**COMMENT # 142**  
MTF FOM ILD

Bruce Champion, TE

# Comment Overview

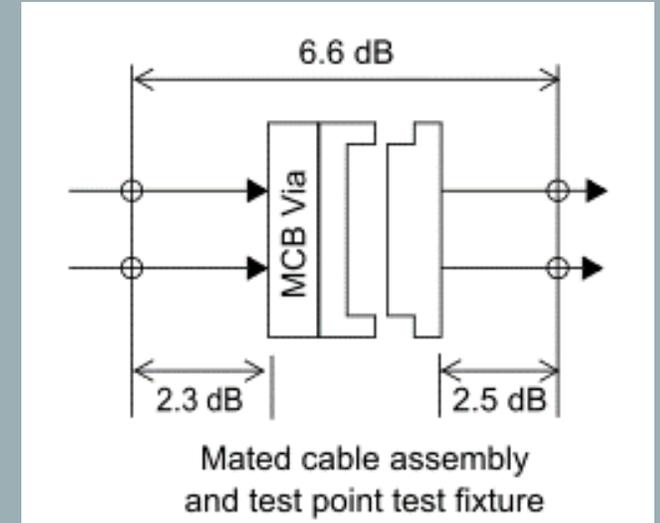
- Comment addresses existing MTF FOM\_ILD limit of 0.13 dB

The FOM<sub>ILD</sub> is calculated according to 93A.4 with  $f_b=53.125$  GHz,  $T_t=8.5$  ps, and  $f_r=0.75 \times f_b$ . The fitted insertion loss and insertion loss deviation are computed over the range  $f_{\min}=0.05$  GHz to  $f_{\max}=40$  GHz. FOM<sub>ILD</sub> shall be less than or equal to 0.13 dB.

# Proposed Limit

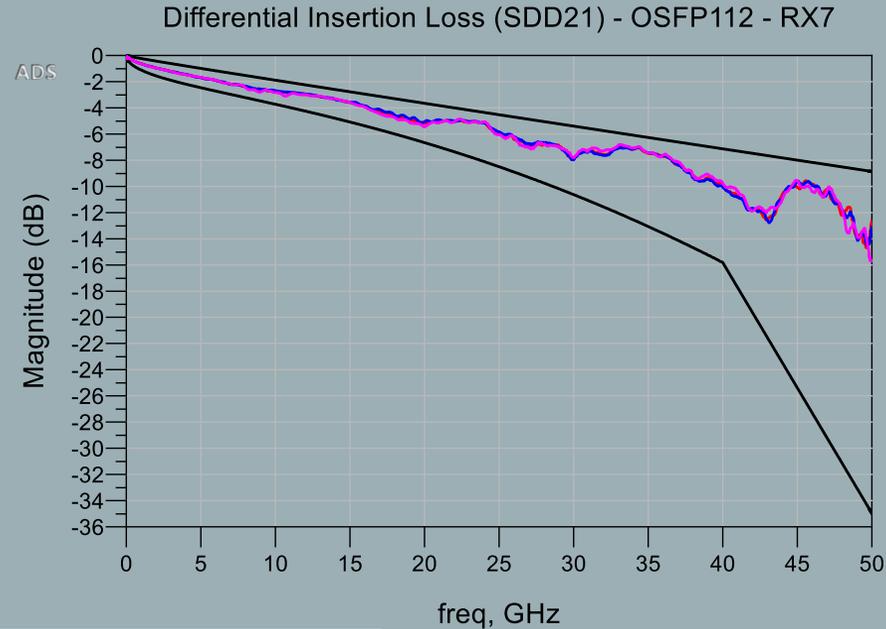
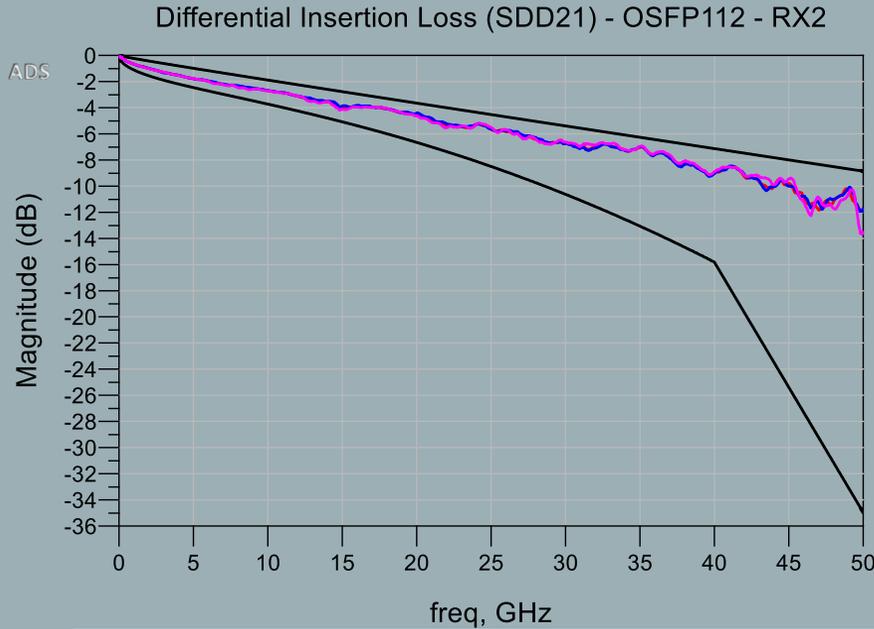
RED - 100Ω MTF  
 BLUE - 95Ω MTF  
 PINK - 105Ω MTF

OSFP ILD					
Pair	100 Ohm	95 Ohm	105 Ohm	Diff 95/100	Diff 105/100
RX1	0.1282	0.116	0.1559	-0.0122	0.0277
RX2	0.0763	0.07	0.0995	-0.0063	0.0232
RX3	0.1126	0.1025	0.1406	-0.0101	0.028
RX4	0.0696	0.0655	0.0891	-0.0041	0.0195
RX5	0.1212	0.111	0.1476	-0.0102	0.0264
RX6	0.0734	0.0692	0.0881	-0.0042	0.0147
RX7	0.1324	0.1218	0.1608	-0.0106	0.0284
RX8	0.0731	0.069	0.0904	-0.0041	0.0173

- Existing limit of 0.13 dB for FOM\_ILD is too stringent to allow for realistic PCB trace impedance variation
- RF test point variation was not included in this study, but can be another contributor
- To allow for various types of manufacturing variation a limit of **0.18 dB** is proposed
